Title: Discuss New Timberbrook Park Plans

1st Review 240039 Timberbrook Park Ph 6 Civil Plans

Re: 1st Review 240039 Timberbrook Park Ph 6 Civil Plans

SITE PLAN
TIMBERBROOK
PHASE 6
HOA OPEN SPACE LOT 15X
BLOCK 37
~AMENITY CENTER~
BEING 2.706 ACRES OUT OF THE
M. GARNETT SURVEY
ABSTRACT NO. 439
CITY OF JUSTIN, DENTON COUNTY, TEXAS

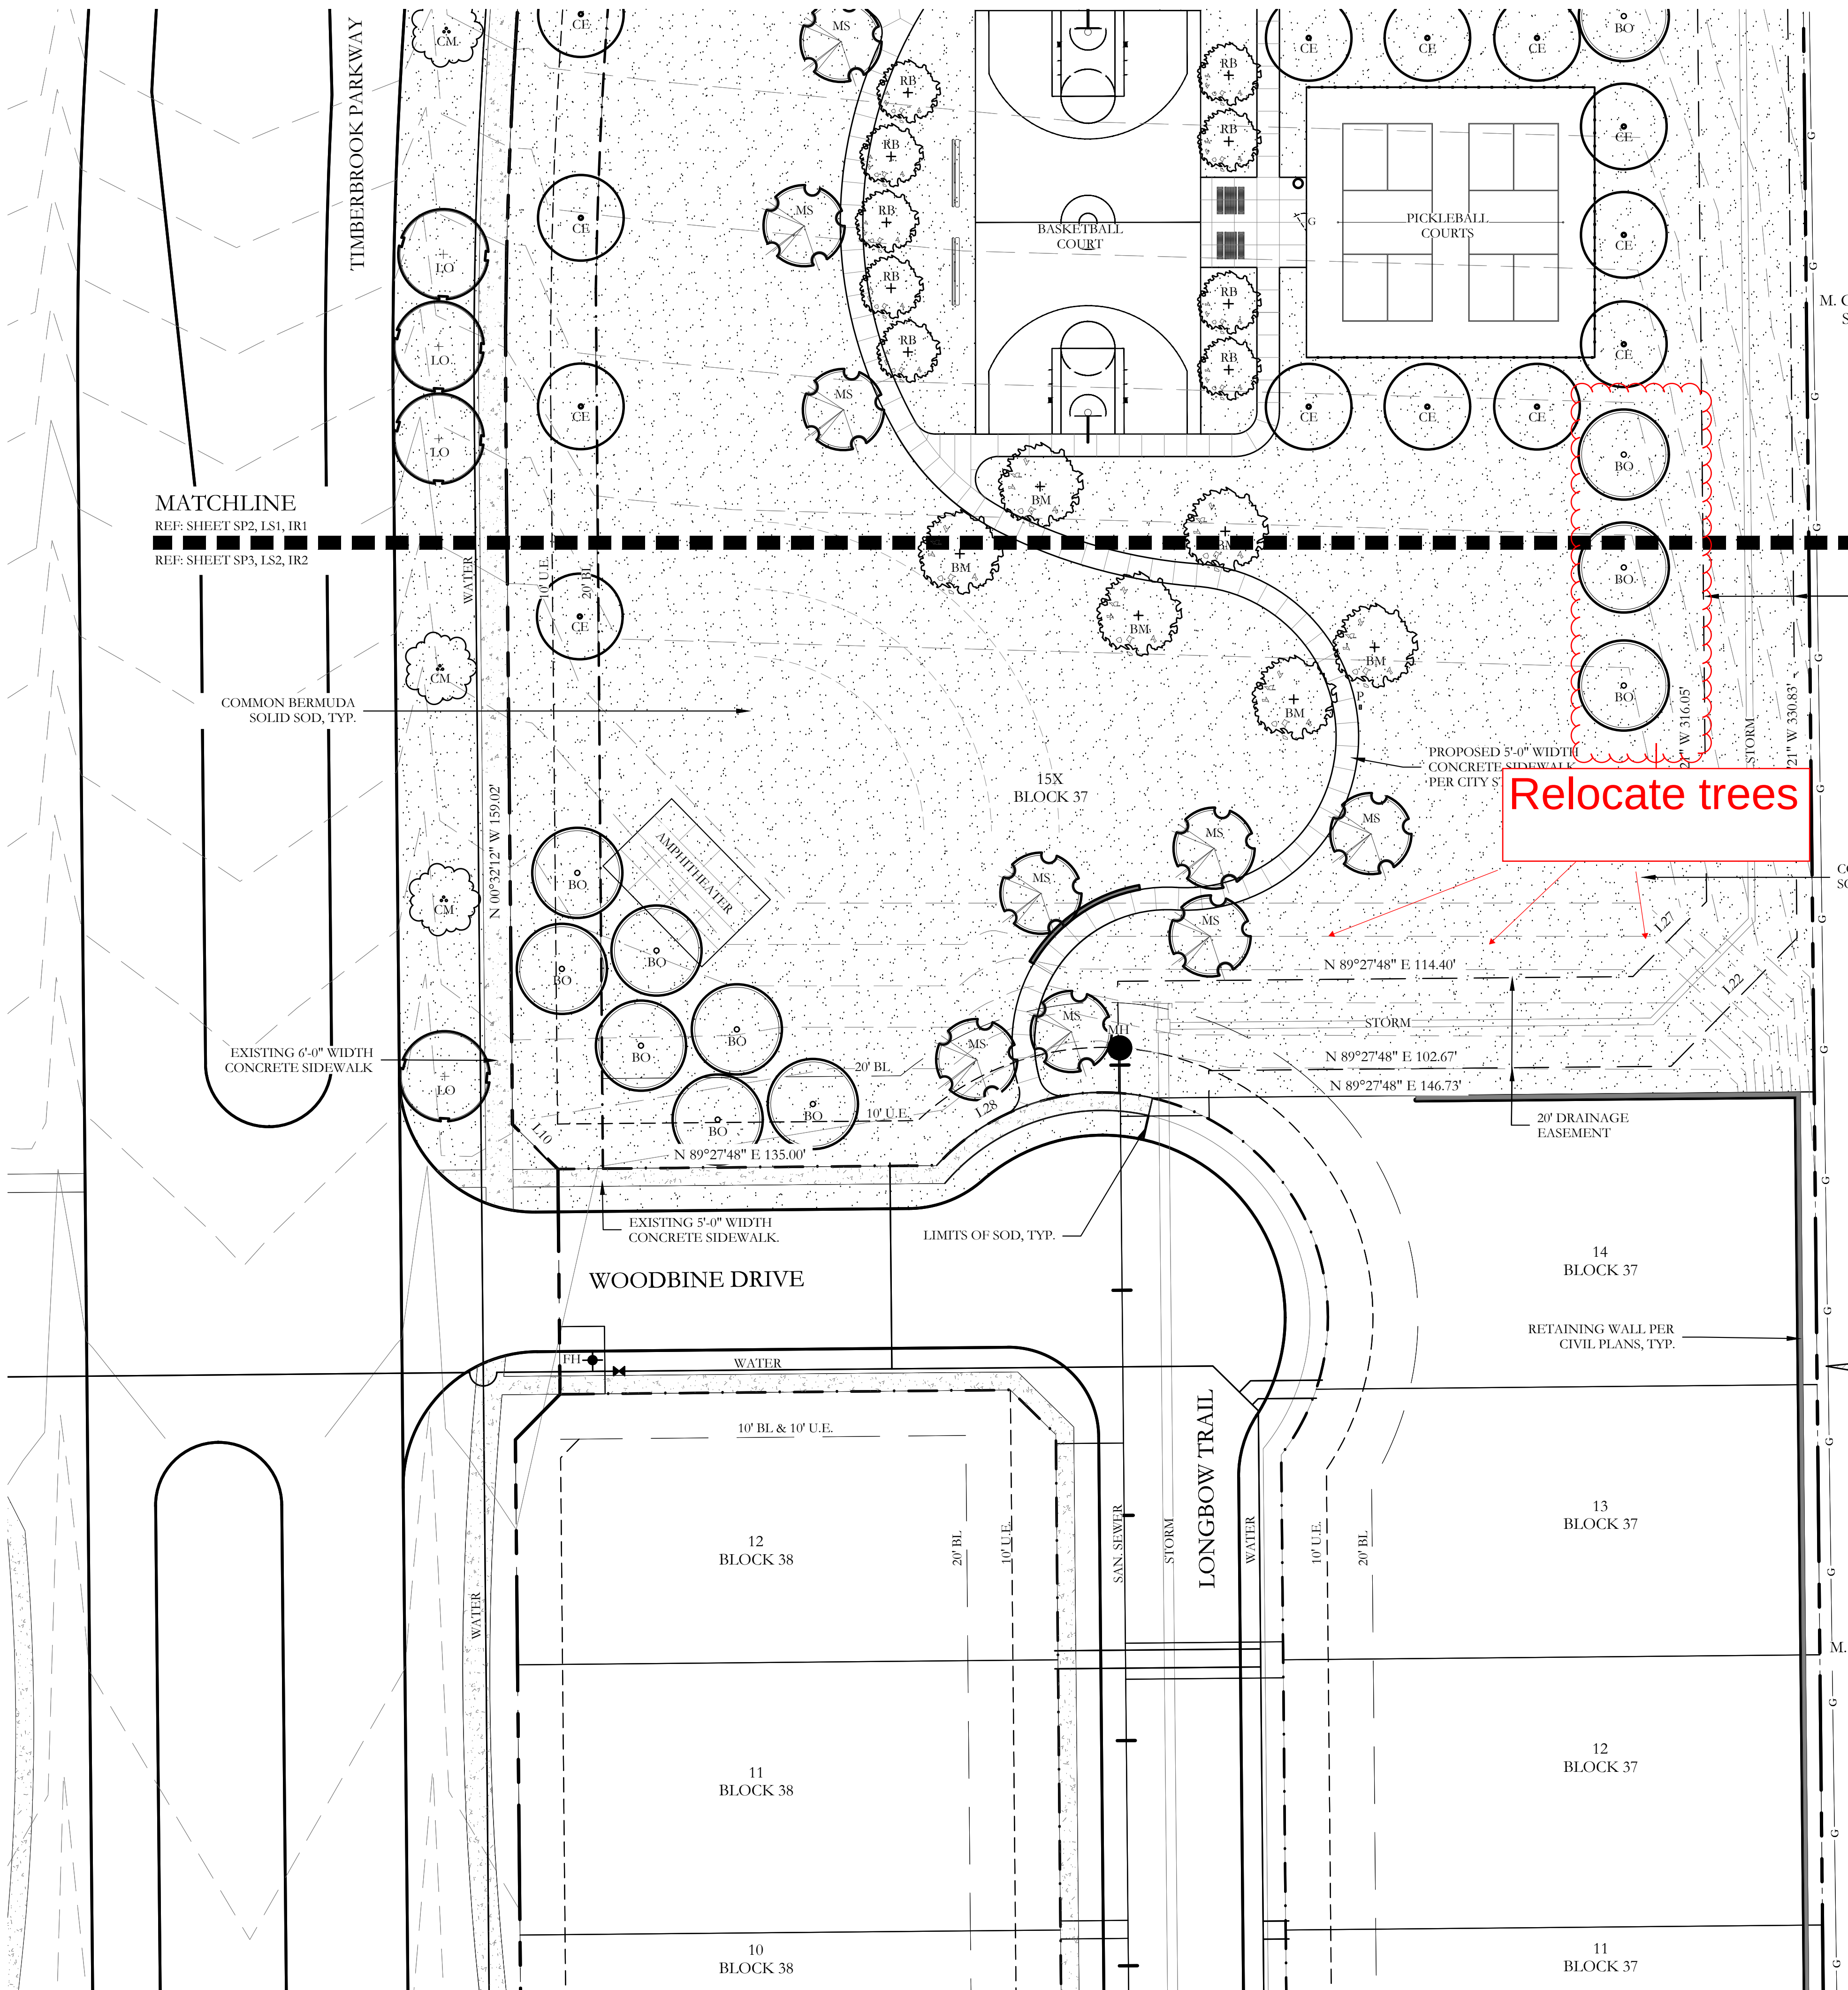
Drainage - The drainage system drains and discharges via headwall at south end of park towards Lot 14. The drainage should tie into the drainage pipe in inlet in order to not put it towards Lot 14 when there is a drainage easement between it and the park. It seems like a way inlet could be installed on line to pick up the water if the headwall is used just grade downstream to capture water prior to reaching lot 14.

1. Remove food truck area and concrete island and replace with parking spaces
2. Add fencing around Basketball court
3. Connect sidewalk on west side of basketball court and pour a concrete pad under player benches

4. Add fencing on west side of Pickleball court up to the concrete pad
5. Add lighting with timers at Basketball and Pickleball Courts
6. Add lighting along sidewalk/pathways

7. Add a roll up style door to the storage area of the bathroom building
8. Relocate trash cans that are between the benches on the north and south side of the event lawn

9. Install necessary hardware in amphitheater concrete pad for future installation of covered structure
10. Dog stations need to accept the same size bags we currently use for other parks or change the dog station to match the same as other parks

11. Remove Mexican Feather grass from picnic table area at event lawn and replace with low maintenance option
12. Monument sign with Park name
13. Veneer to be cohesive and consistent with all buildings, signage and structures

14. Stainless steel bathroom fixtures

Extinguisher in between restrooms and one on the covered picnic table area.

Knox Box or similar device as approved by the Fire Department located at the front of restrooms with master key.

Please include monument signage location and rendering. We would also like the monument signage to be constructed at the same time as the park.

Automatic time lighting for basketball Court and Pickleball Court.

Recommend two trees to be relocated. See mark up.
